Trials Joint Industry Project

***Trial Application of the
API RP 2A-WSD Draft Section 17***

TRIAL APPLICATIONS

PMB Engineering Inc.

Figure 1-1 Section 17 - Platform Assessment Process
Metocean Loading

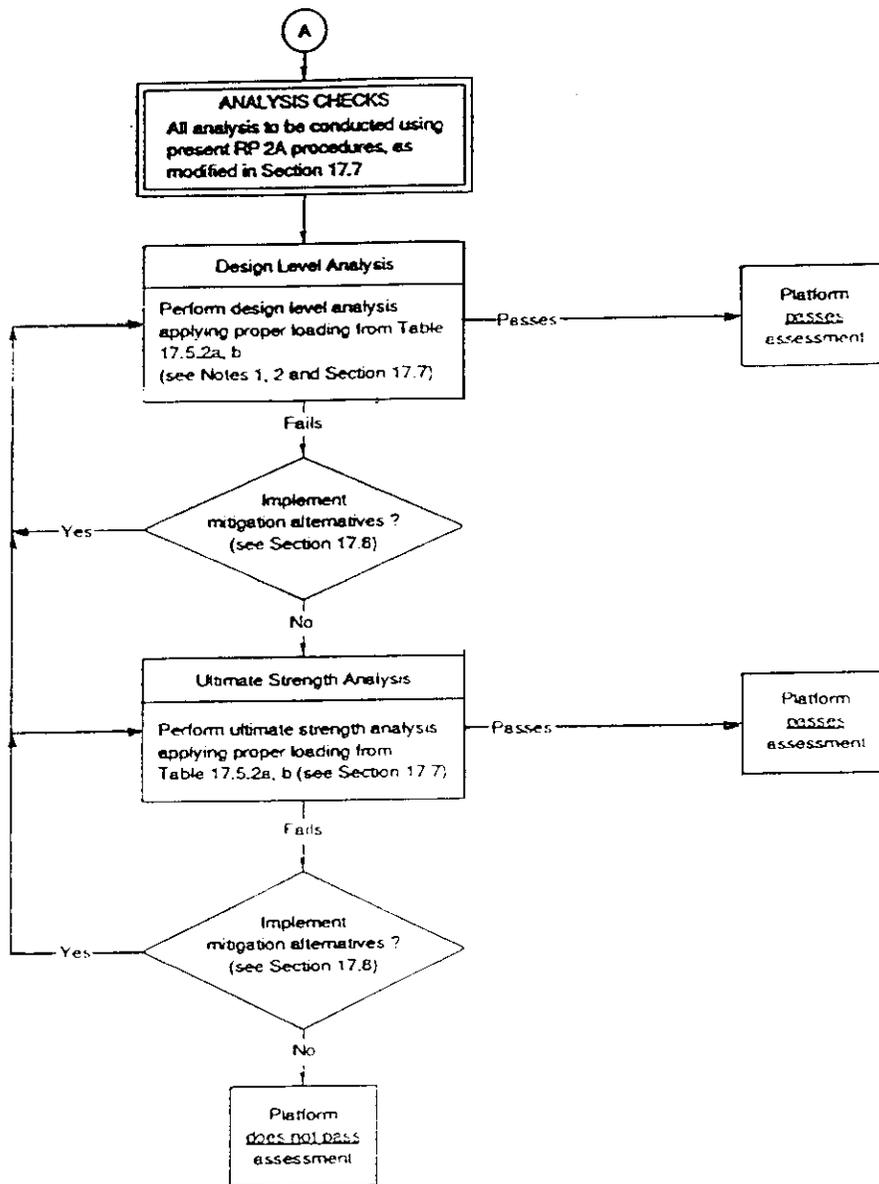
- Another participant stated that all platforms will need to be assessed per Figure 17.5.2. API TG noted that there may be a need for an additional block in Figure 17.5.2 clarifying the API requirements for Gulf of Mexico platforms installed prior to 1977.

All the triggers to perform assessment should be included in the flow chart of Figure 17.5.2 to make it more complete.

1. Figure 17.5.2, Page 6, Note 1: "Design Level Check". It is not clear if what is meant is a "Design Level Analysis" or "Design Basis Check".
2. This Section makes the following statement

- 3a. The assessment process flowchart (Figure 17.5.2) does not reflect a check to determine if platform damage or increased platform loading is significant according to Section 17.2.6. Some analytical work is necessary to determine if the damage or increased loading is significant. The analytical work may show the damage or increased loading to be insignificant and, if no other initiators exist, the platform passes assessment. This process for an alternative design level analysis is discussed in Section 17.5.2.3.

- 4a. In Figure 17.5.2 there needs to be a mechanism in the flow chart which allows a termination to the assessment process when it is determined that no personnel or facilities are being added and there is no significant damage or load increase. A proposed revision to the flow chart is attached at the end of this section (see Figure 4-5).
- 4b. In Section 17.5.2.3, the third sentence says that "requirements are described in Section 17.7.2". Section 17.7.2 is entitled "Design Level Analysis Procedures". The nature of Section 17.7.2 seems to state neither requirements or procedures.
- 4c. In Section 17.5.2.4, the fifth sentence says that "Requirements are described in Section 17.7.3". Section 17.7.3 is entitled "Ultimate Strength Analysis Procedures."

Based upon the discussion held at the meeting, the API TG updated Figure 17.5.2 in their June 28, 1994 revision.

Figure 4-4

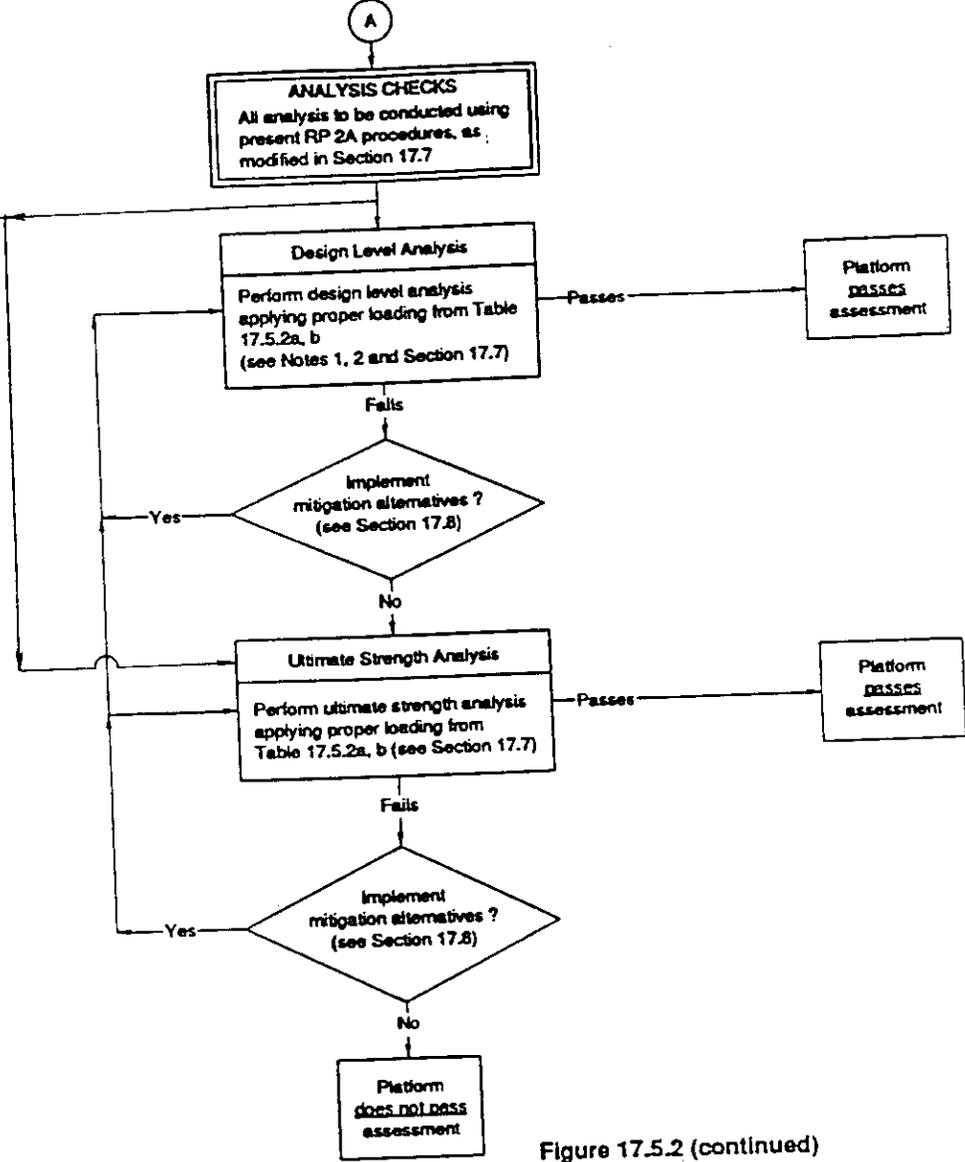
- 2b. (p.5) First paragraph read as "-----". However, it is permissible to bypass the design level analysis and to proceed directly with an ultimate strength analysis. ----. This option should be reflected in Figure 17.5.2 (continued) – page 7 (see Figure 4-4).

PLATFORM ASSESSMENT PROCESS METOCEAN LOADING FLOW CHART GULF OF MEXICO

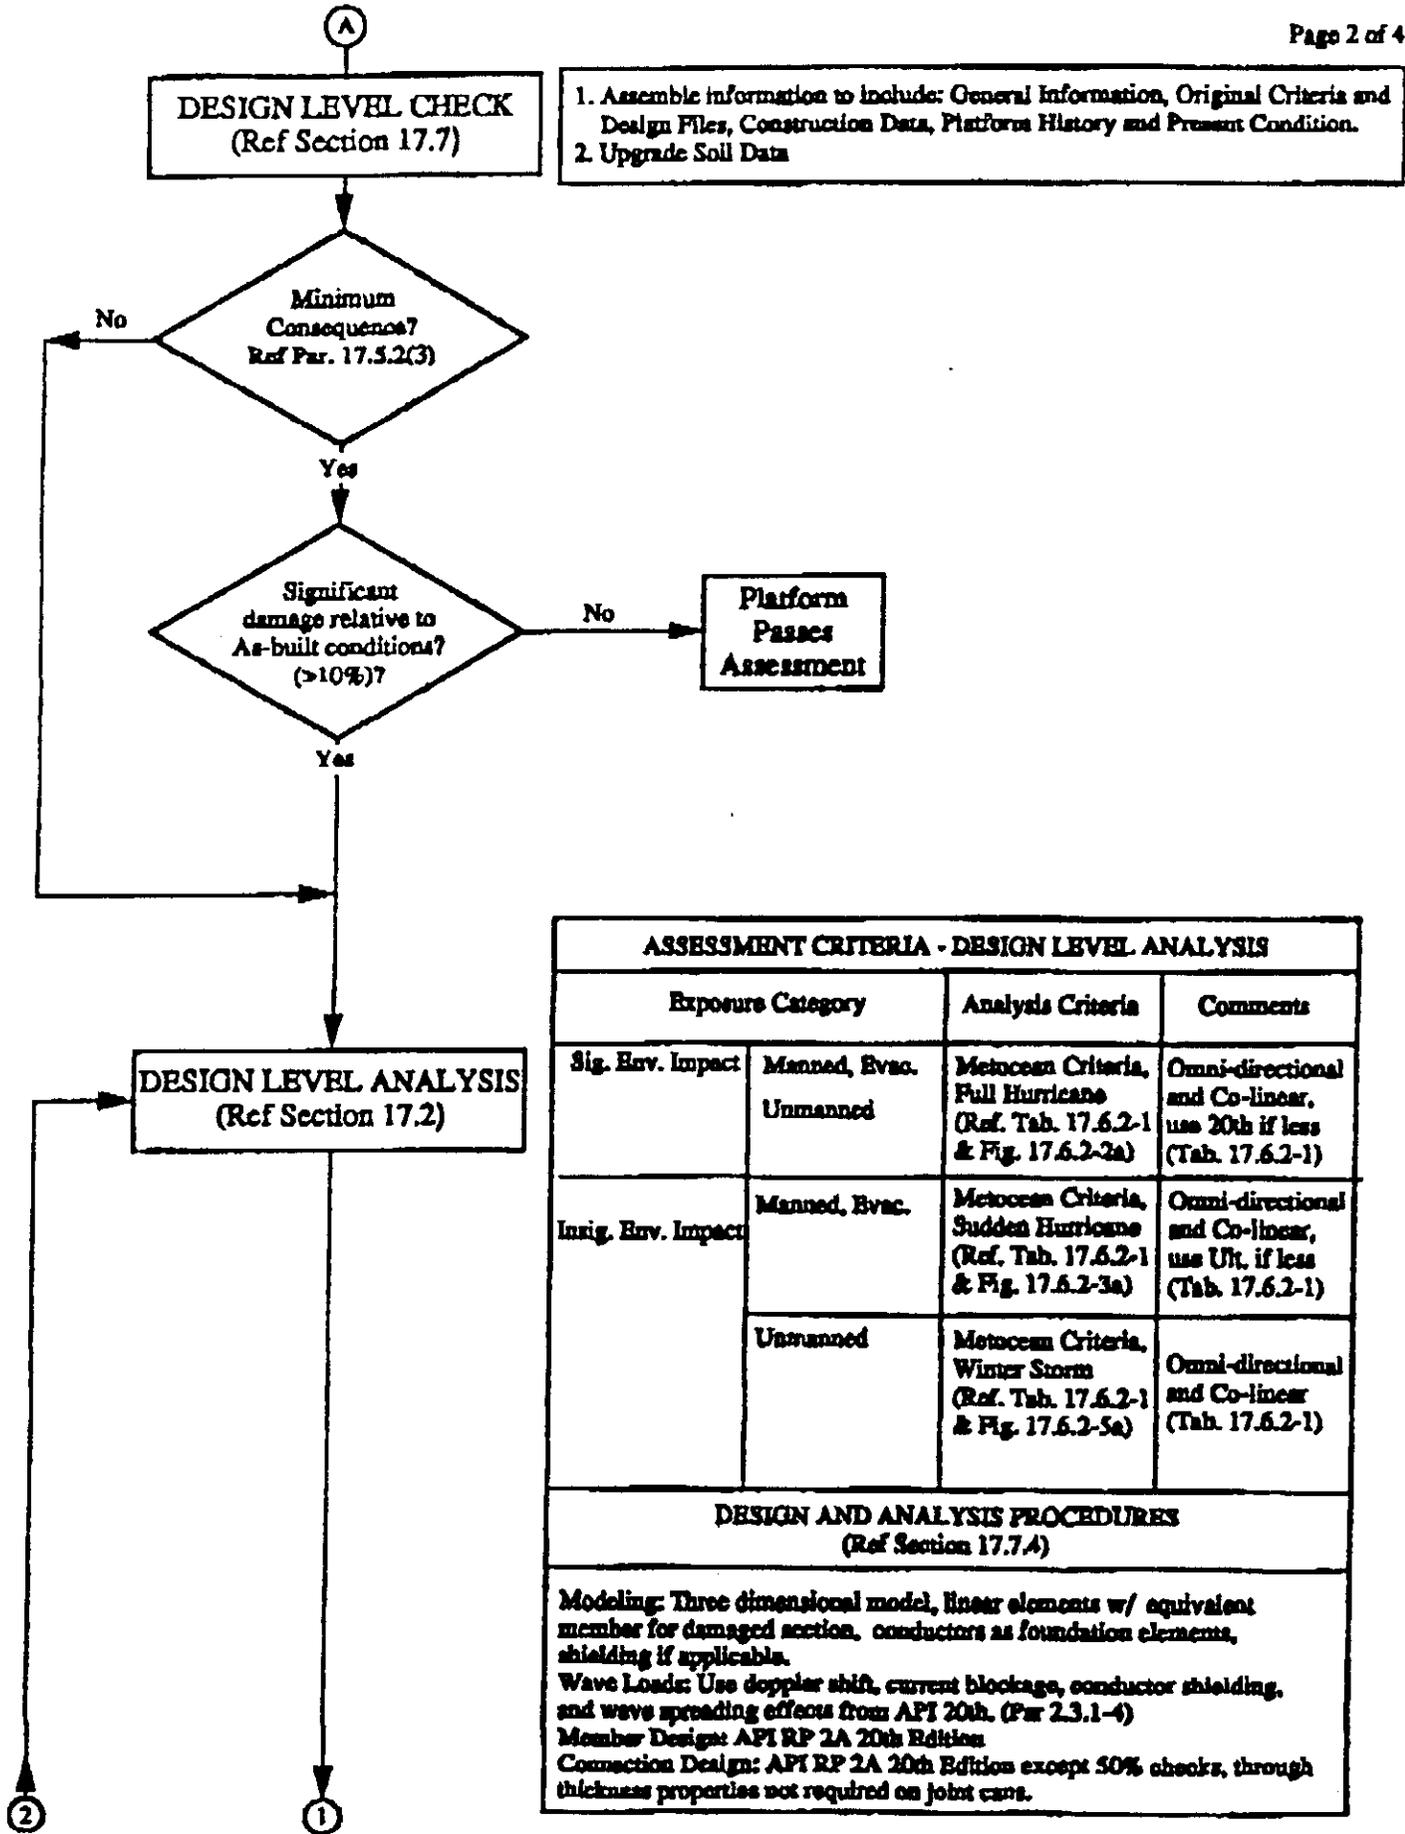
Please reference the attached detailed flow chart for the platform assessment process as contained in Section 17 (Metoccean loading only). This flow chart represents our best effort at understanding the requirements of Section 17 and your comments are appreciated. In addition we have the following questions:

1. It is our understanding that all existing Gulf of Mexico platforms will be required to undergo a Platform Screening (Ref. Flow Chart, p. 1 of 4). Is this correct?

2. Assuming the answer to 1. above is yes, then it appears that it will be necessary to perform a Design Level Check (as a minimum) on all platforms designed prior to API 9th Edition (1977). Is this correct?

3. From Pars. 17.2.6 and 17.5.2(3) it appears that one way of determining if the damage is significant would be to compare the critical wave shear of the as-built platform (no overstresses) to that of the damaged platform (no overstresses) allowing for an adequate reduction in capacity of the damaged member(s). Since other solutions could be proposed for making a comparison, would it be advisable for some wording to be added to Par. 17.2.6 which would clarify the comparison method to be used?
